Upgrading the SpO2 board from MS-11 to MS-2011

Note: This procedure only applies to devices containing an MS-11 SpO2 board.

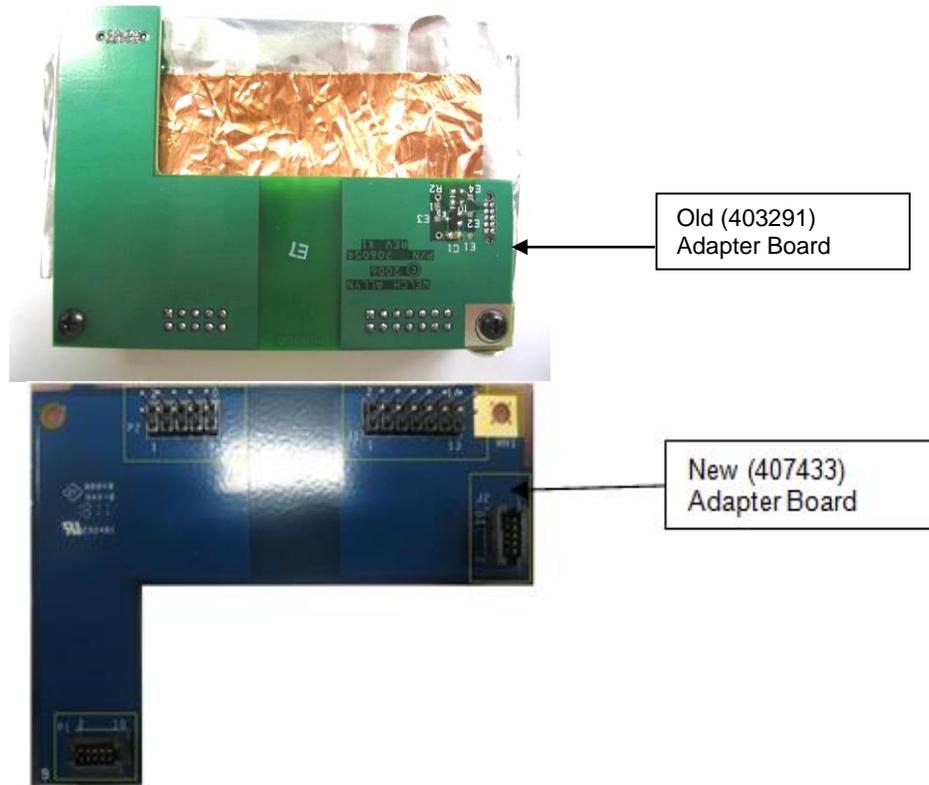
The Masimo **MS-11** SpO2 module was obsoleted in 2011. Thus, a newer version, **MS-2011**, is available for use in SPOT Vital Sign Monitors. When the SpO2 assembly needs repair, all SpO2 assembly replacements should use the **MS-2011** module.

The upgrade will require a new **MS-2011** Module (726572 / MASIMO MS-2011 OEM PCBA 3772 FW V5201), and a new interface board (407433 / SPOT ON MASIMO ADAPTER PCA, MS-2011). New cables or sensors must be purchased separately. For convenience, these two boards, along with a copy of these instructions, are included in the Service Kit: 4200-410 / SPOT MASIMO REPLACEMENT KIT.

While replacing the **MS-11** (part # 031-0160-01 / MS-11 OEM PCB SPOT ON) with an **MS-2011** (part # 726572), replace the interface board (part # 403291 / SPOT ON MASIMO ADAPTER PCA) with the new version, (part # 407433).

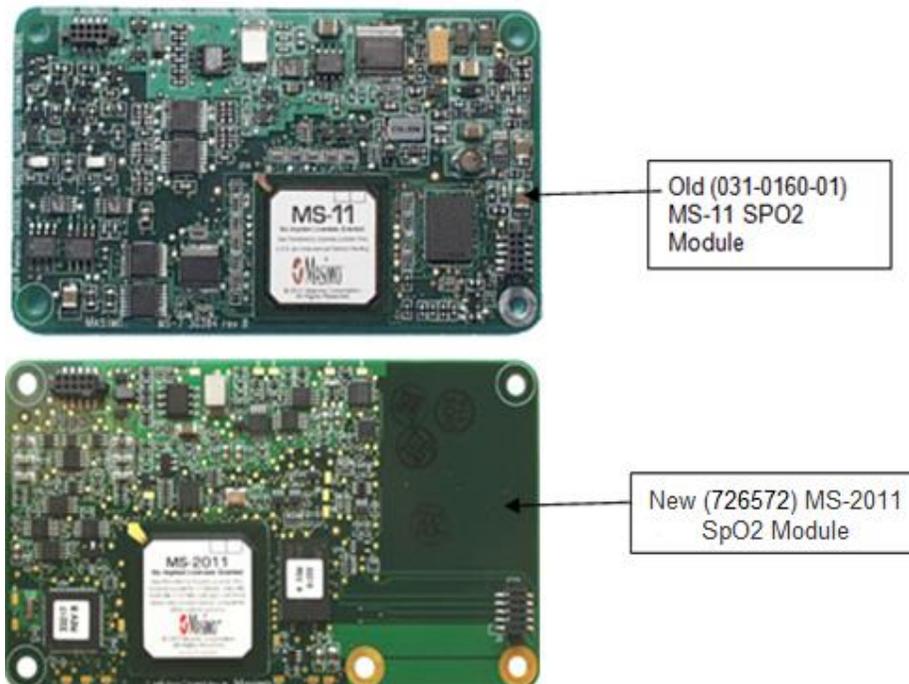
3. Remove the SpO2 assembly. Note the different color between the old green (403291) and the new blue (407433) adapter boards.

4. Unwrap the EMI shield from the SpO2 Module. Note the difference between the old (MS-11) and the new (MS-2011) modules.

5. Wrap the MS-2011 module in the EMI shield.
6. Assemble the **MS-2011** module into an SpO2 assembly with the **407433** (blue) board.
7. Attach the assembly to the main board and re-assemble the main board in the unit.
8. Re-install the LCD and complete assembly of the unit.
9. For assembly / disassembly details, or to verify proper functionality, refer to:
